SR-2 – ADVISORY STAFF REPORT (05-08-2026)

ADDRESS: 1616 CHICAGO

HISTORIC DISTRICT: BOSTON-EDISON

APPLICATION NUMBER: HDC2026-00139

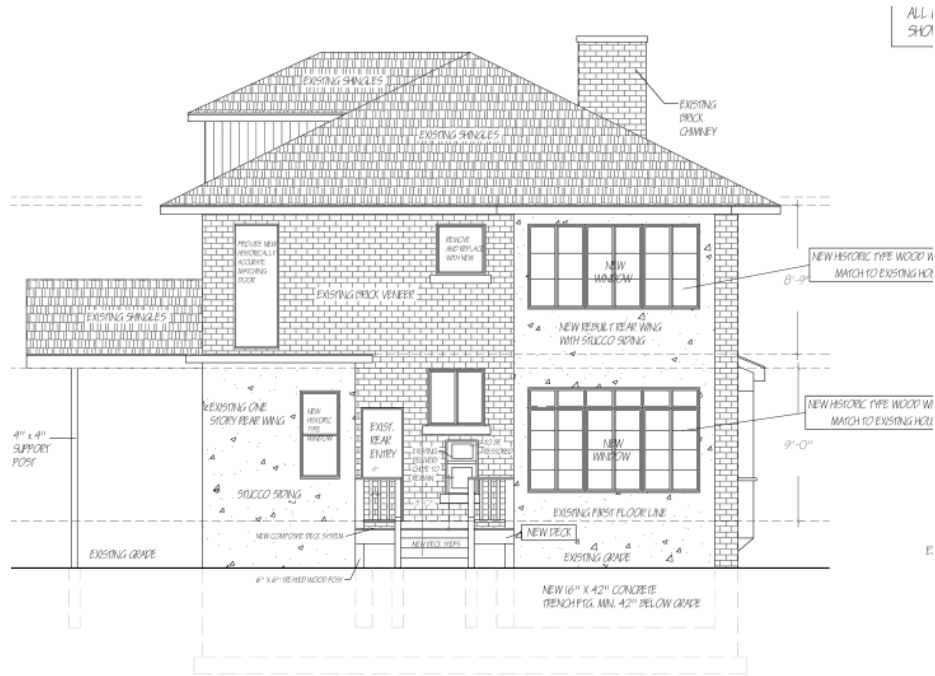
3 sets of paired 3-lite wood casement windows

Flat roof w/rafter tails/brackets

3 sets of paired 4-lite wood casement windows with 3-lite transoms

2 sets of paired 4-lite wood casement windows with 3-lite transoms

Appearance prior to the unapproved removal of the two-story wing, second story window, and one-story wing's stucco cladding at the building's rear wall. While detail photos of its eaves/soffit/fascia do not exist, the area does appear to match main roof's the eaves/soffit/fascia, to include the presence of decorative brackets/rafter tails

Proposed west side elevation

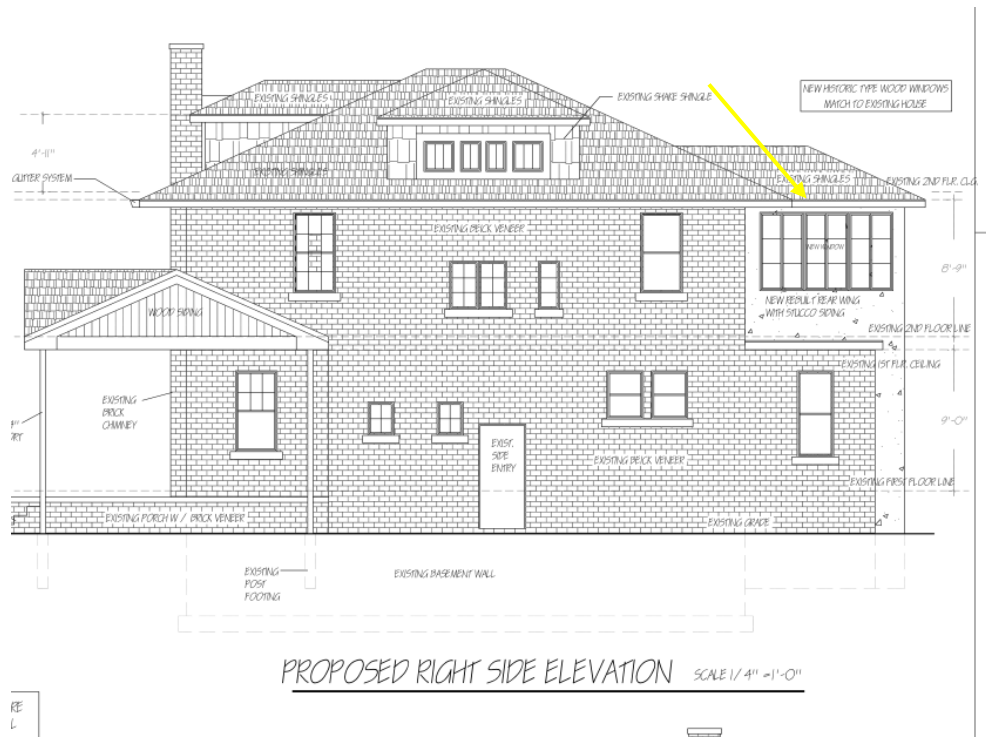
- The original wing had a flat roof while the proposed has a hipped roof
 - The original wing's roof had deep overhanging eaves with decorative wood brackets/rafter tails. Also, the soffit and fascia were wood. The new design proposal does not specify that these original conditions will be matched

- At the original wing's first story, the transoms included 3 lites each. The proposed new design proposes 2-lite transom windows
 - The original windows were wood, with true divided lites. The proposed new windows are wood units, but the application materials do not specify if the windows will be simulated divided lite, true divided lites, or will have muntins between the glass.

Proposed east side elevation. Note that this drawing only depicts the second story of the proposed “rebuilt” sunroom’s east façade (yellow arrow)/the submitted set of drawings does not provide a full elevation drawing of the proposed “rebuilt” sunroom wing’s east façade.

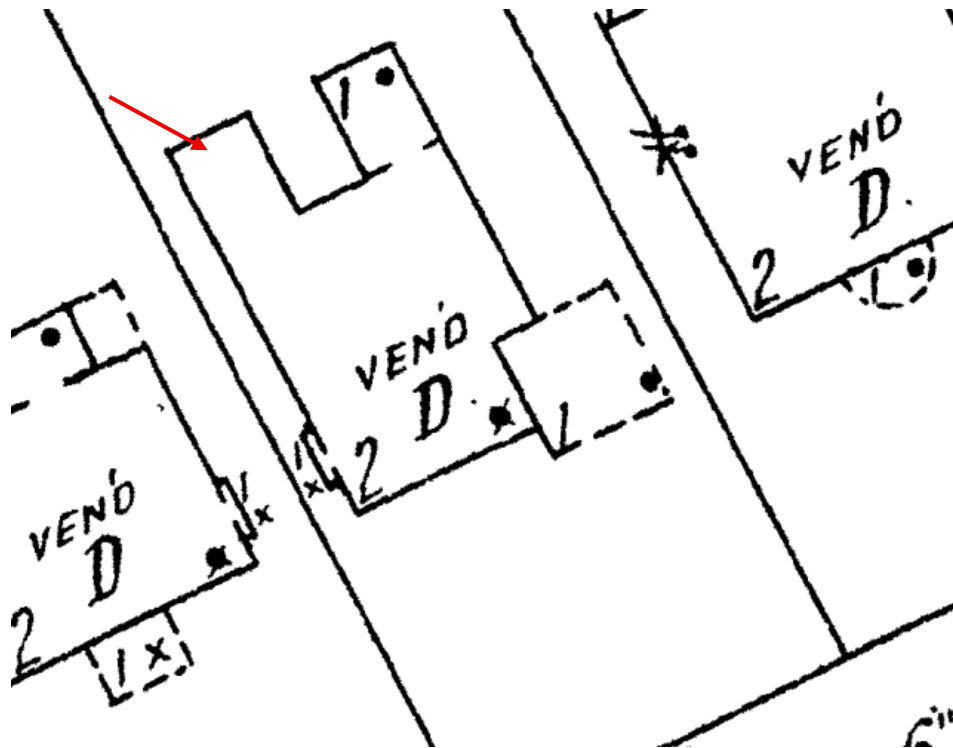
- The current application does not include a full elevation drawing of the proposed wing's east façade/does not depict its first story. Details are limited to the plan's indication that a single wood French door and two sets of wood windows will be installed at this location. However, the lite configuration, operation, presence of transom, etc. is not clear due to the lack of an elevation drawing.

1991 Sanborn Map. Footprint of 1616 Chicago (red arrow) prior to unapproved removal on the two-story rear

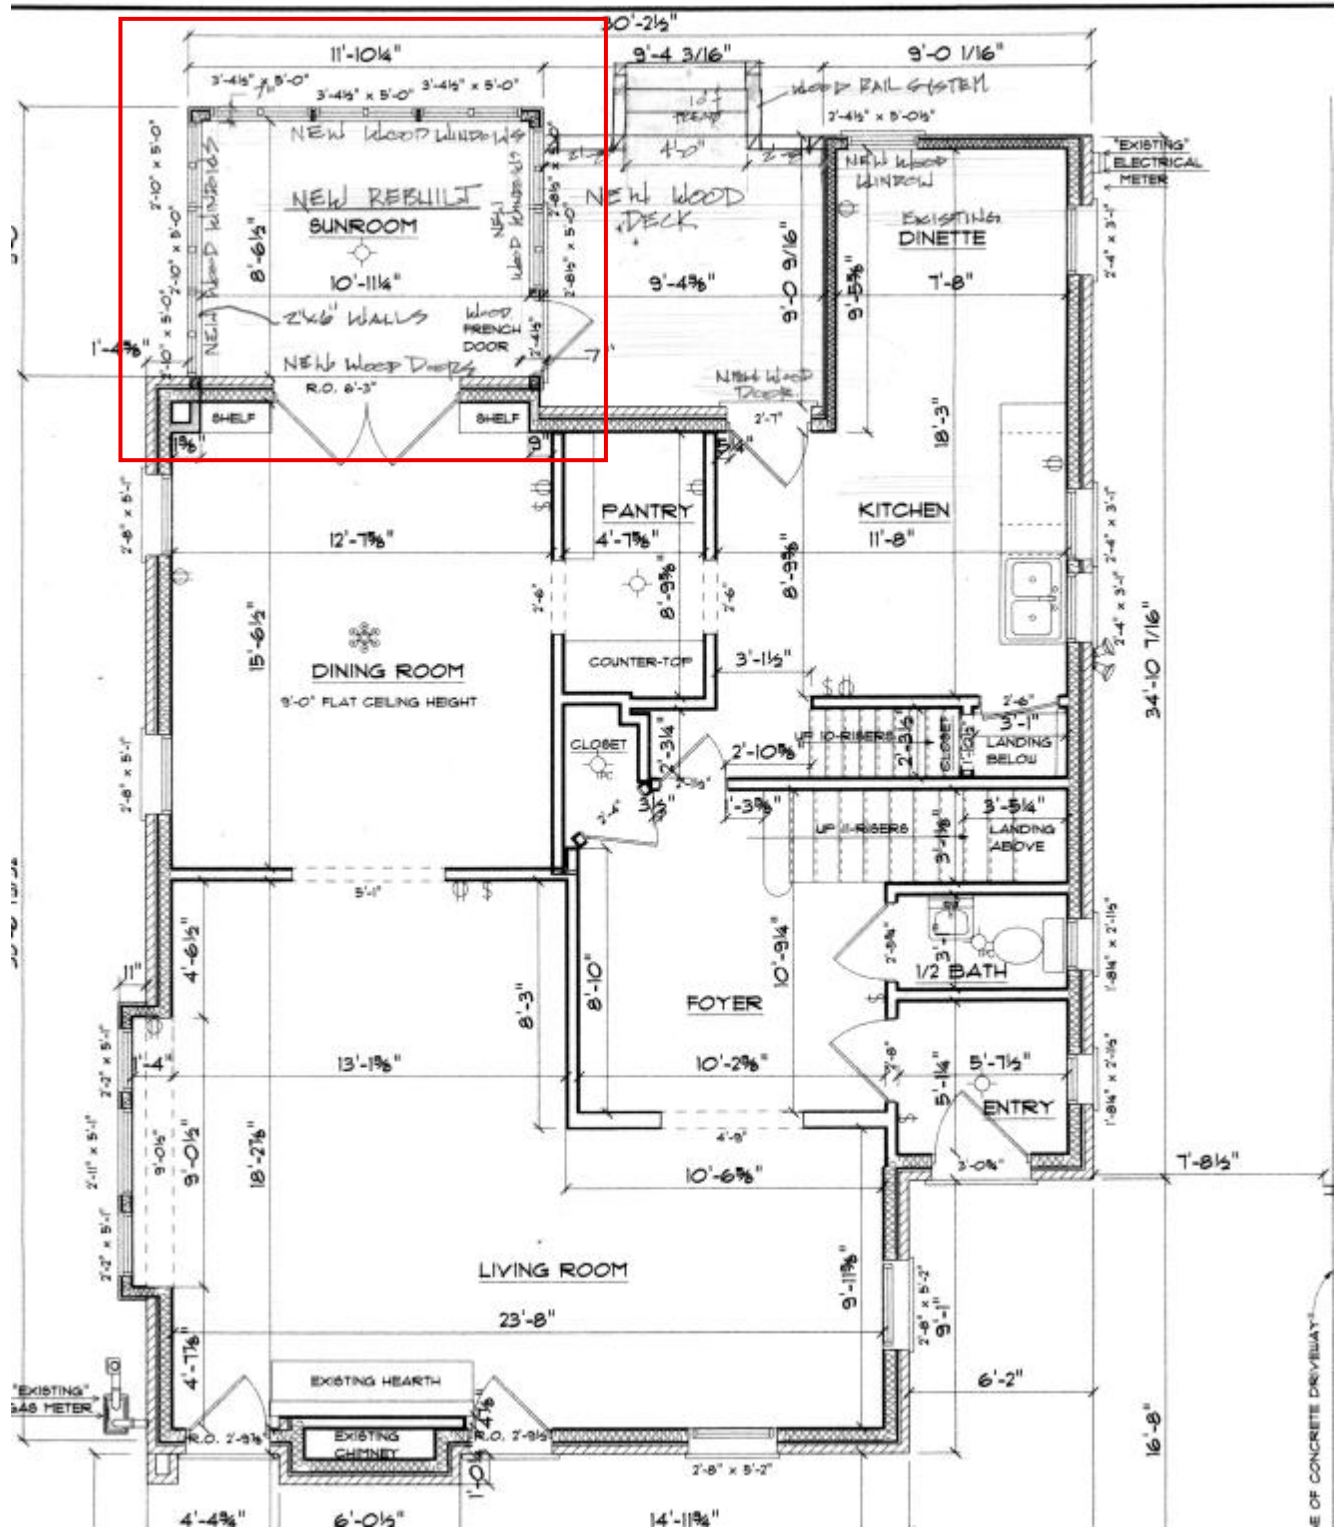
wing.
